MUKILTEO FERRY TERMINAL (PHASE 2) FERRY TERMINAL CONSTRUCTION

VOLUME 3 OF 8

VOLUME 3 SHEET INDEX - CONT

FILE NAME: PW:\WSF\Mukilteo\14W121_FerryTermConst\CADD\KPFF\18w121io00.09.dlv										 Washington State Department of Transportation WASHINGTON STATE FERRIES	/ /2017	SR 525 MUKILTEO FERRY TERMINAL (PHASE 2) FERRY TERMINAL CONSTRUCTION	10.09														
PRINTED: 9:19:32 AM 1/11/2019	LAST PRINTED BY: R. JACKSON				FED.AID PROJ.NO.	WA-2017-007-00	REGION NO. STATE 10 WASH	JOB NUMBER 18W121	CONTRACT NO. 00****					SHEET 10 OF 1521 SHEETS													
													SUBMITTAL DATE: 1/18/19		DESIGNED BY: A. GASTINEAU	1/18/19	ENTERED BY: R. JACKSON	1/18/19	CHECKED BY: D. ALIRE	1/18/19	MAR PROJ ENGR: C. TORRES	DIR TERM ENGR: N. MCINTOSH	ASST SECRETARY: A. SCARTON	CONFORMED PLANS REVISION	1/18/19	DATE	BY

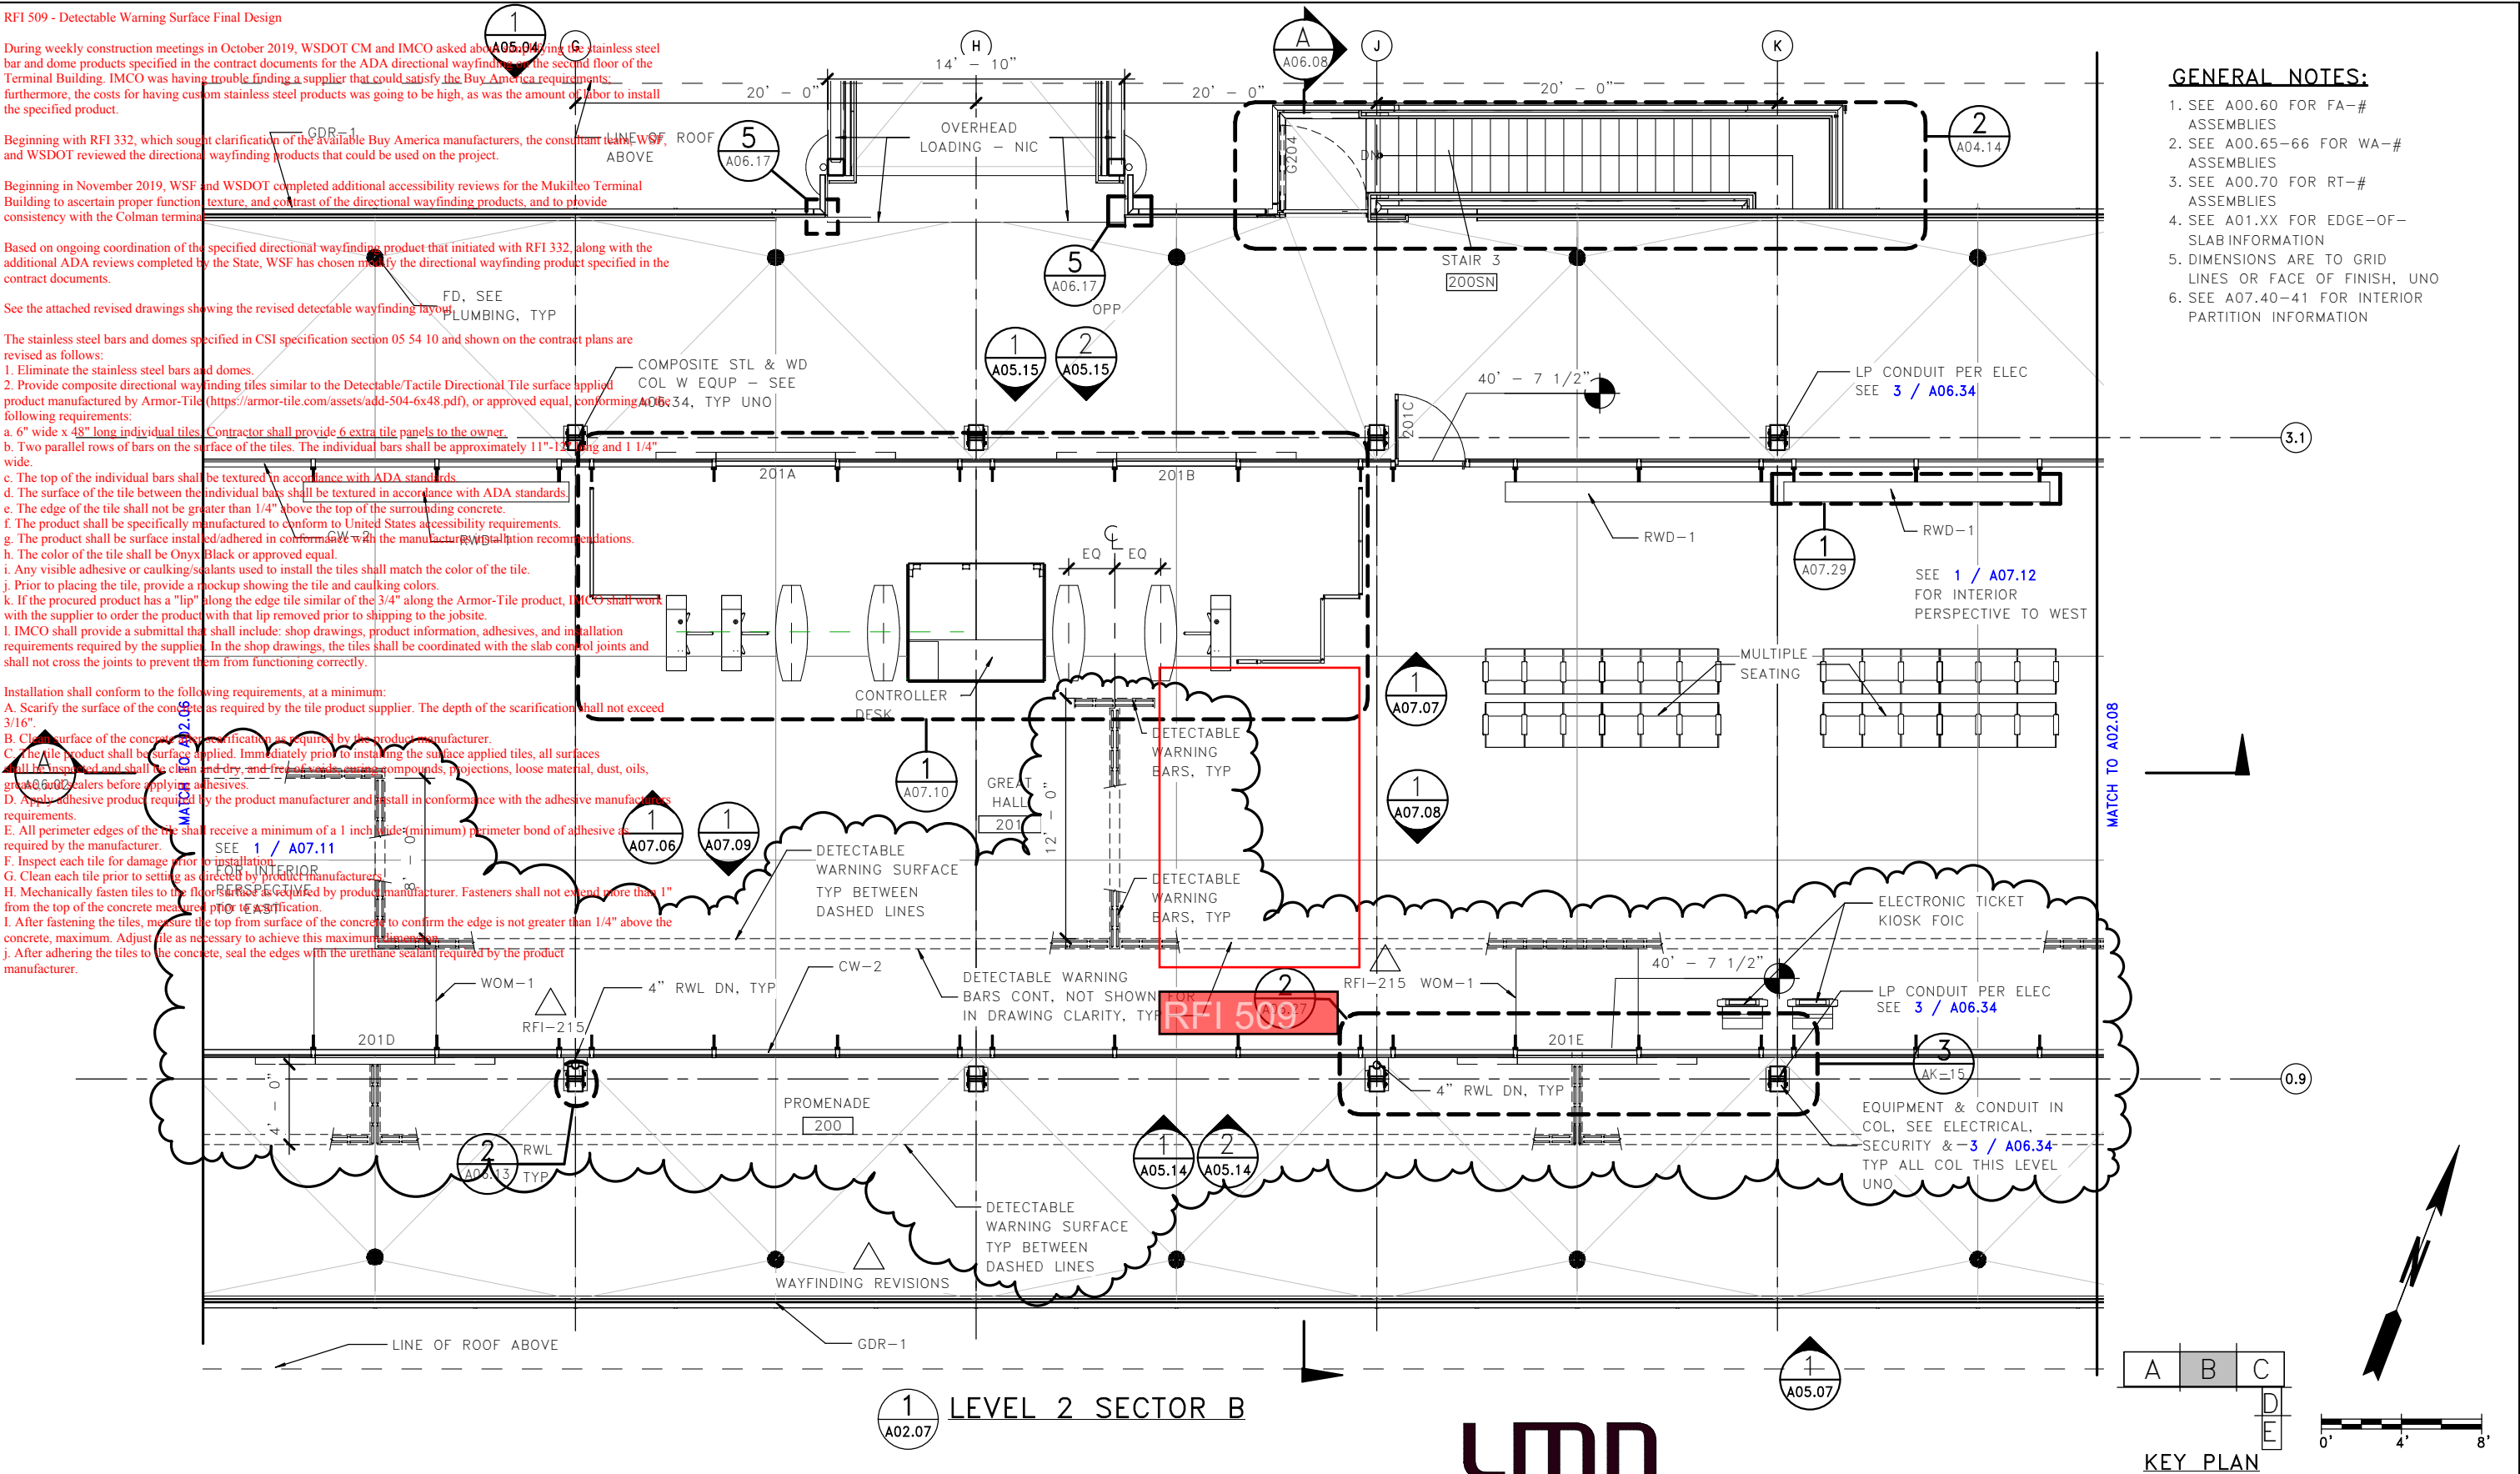
The stainless steel bars and domes specified in CSI specification section 05 54 10 and shown on the contract plans are revised as follows:

1. Eliminate the stainless steel bars and domes.
2. Provide composite directional wayfinding tiles similar to the Detectable/Tactile Directional Tile surface applied product manufactured by Armor-Tile (<https://armor-tile.com/assets/add-504-6x48.pdf>), or approved equal, conforming to the following requirements:

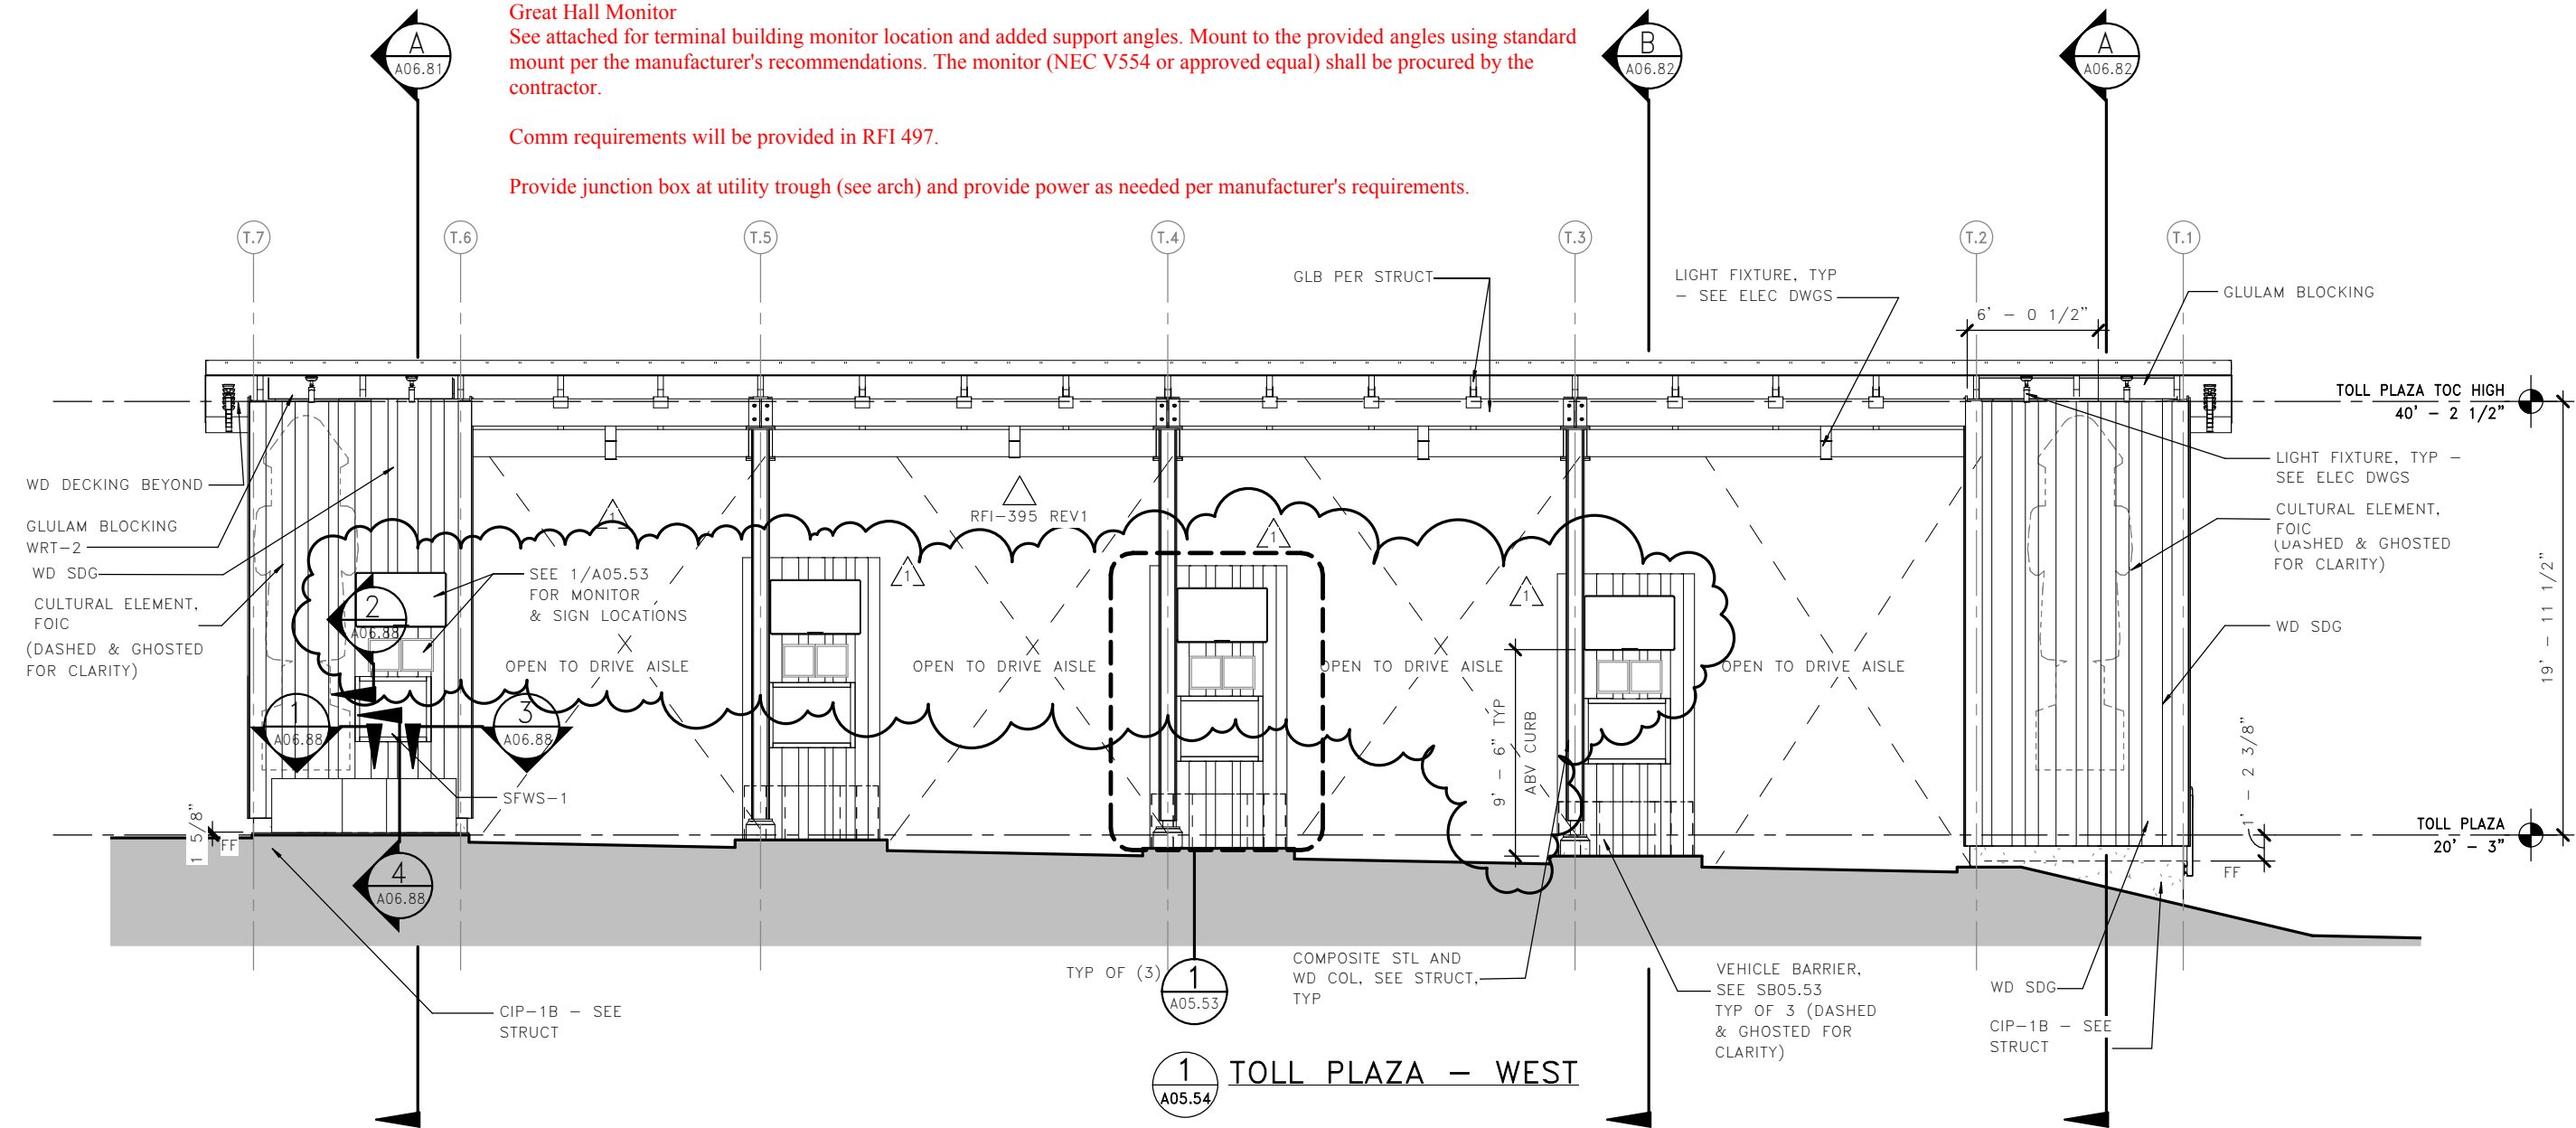
See attached revised A05.53 and A05.54 for the toll booth monitor locations. The outdoor monitors (Samsung OH55F or approved equal) shall be procured by the contractor. Attach using standard mount per manufacturer's recommendation. Provide 2x6 blocking between the steel studs at toll booth 4 at attachment points (see attached sketches SK-54A -- SK-54C). At toll booths 1-3, provide similar exterior details to toll booth 4. If the monitors cannot be installed into studs per manufacturer recommendations, provide 2x6 blocking.

Provide (2) 1" conduit to attic. Further comm requirements will be provided in RFI 497.

Provide power as needed per manufacturer's requirements.

RFI 221 - Roof Radius
Option 1 - We are concerned about not having a solid substrate below the roofing when people walk on the roof and also concerned about condensation issues with a void (air) below the metal roofing.

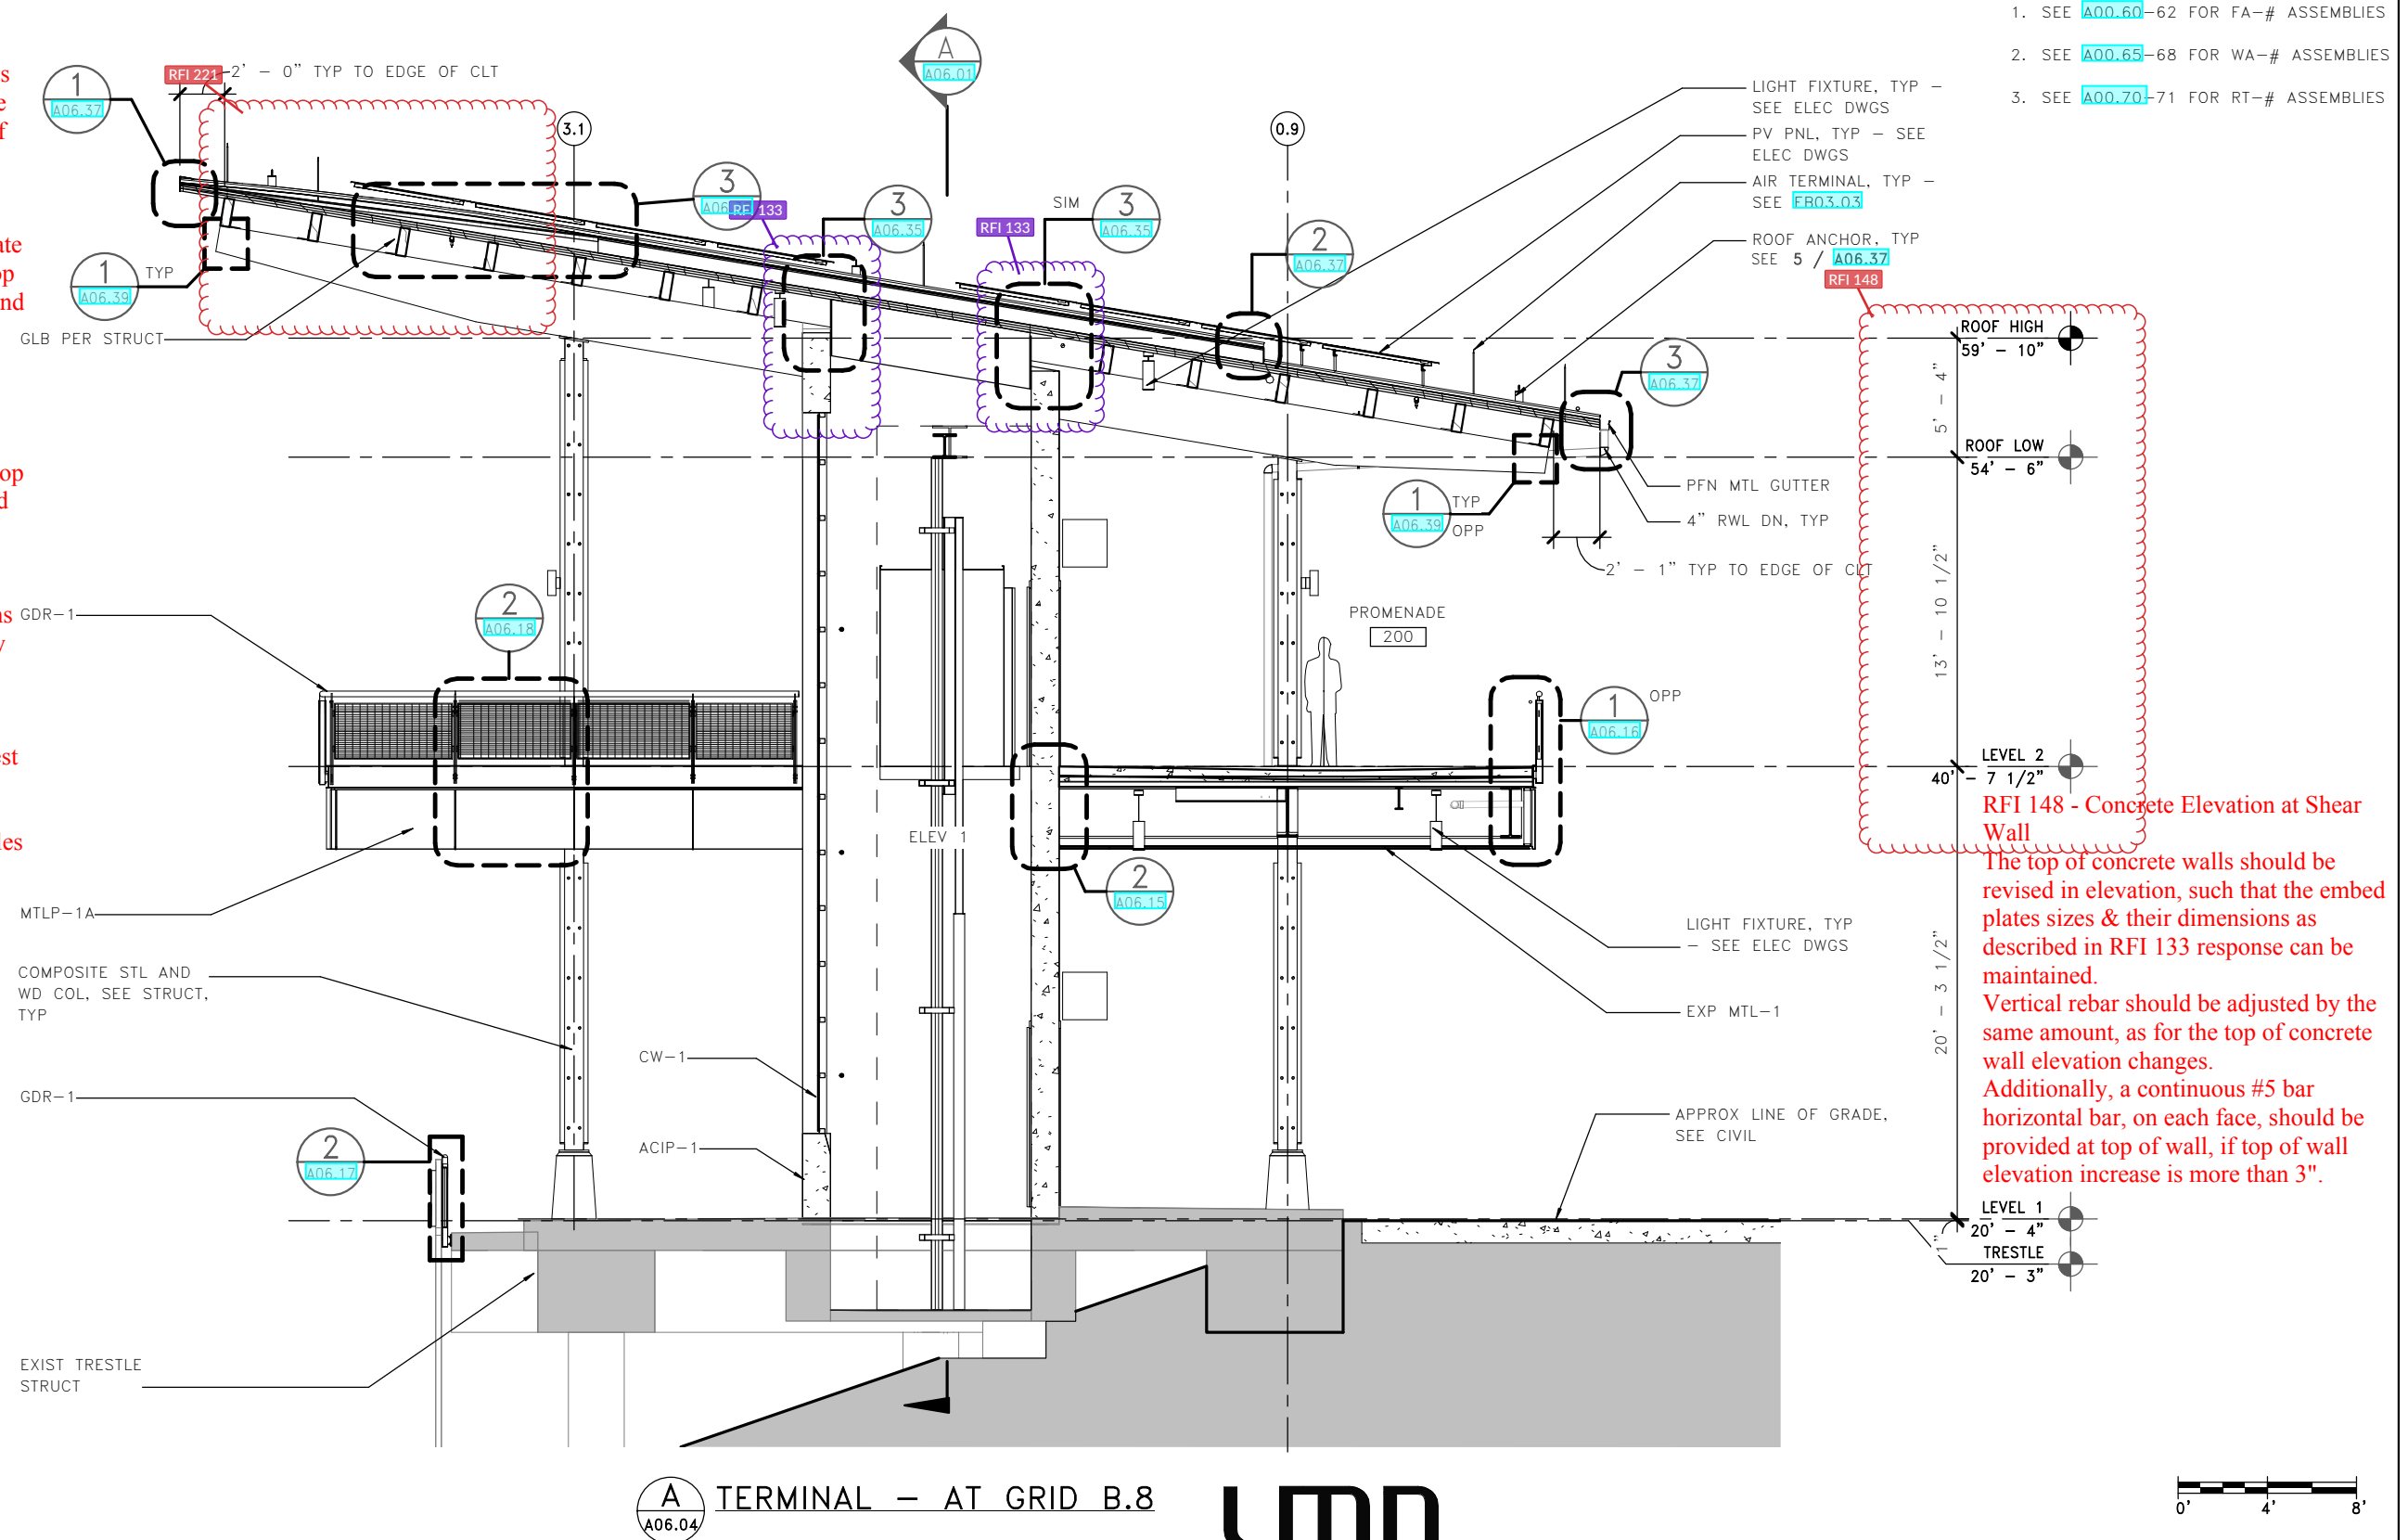
Option 3 - Can the curved portion of the roof be changed to a taper - this would create a "break" in the roofing at the point of transition between straight and tapered insulation (1'-1" south of grid 3.1 - see 3/A06.38) . Does the roofing sub have a standard detail to work for that kind of transition?
